The following information changes the competitive process documents issued on January 30, 2025.

ADDENDUM M-1

Project Name: **Parkdale Elementary School Accessibility Renovations**

PARKDALE ELEMENTARY SCHOOL ACCESSIBILITY RENOVATIONS
139 PARKDALE AVENUE HAMILTON, ONTARIO

DETAIL 8 – PIPE HANGER NOT TO SCALE

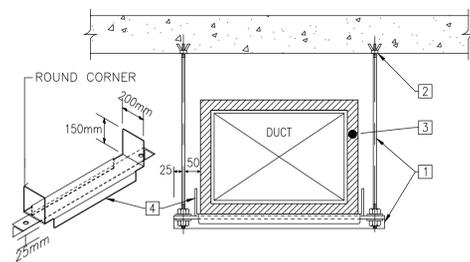
1. **M101** – individual tags assigned to exhaust fans, added specification for hydronic piping.
2. **M102** – added detail for pipe support.
3. **M300** – added existing convectors in washrooms 108A and 108B for reference.
4. **M301** – added tag for EF-2; removed note#5 from detail 3.
5. **M302** – drawing added to the package to include for removal and reconfiguration of heating water mains and branch piping in crawl space to allow for installation of new elevator shaft and structural steel.
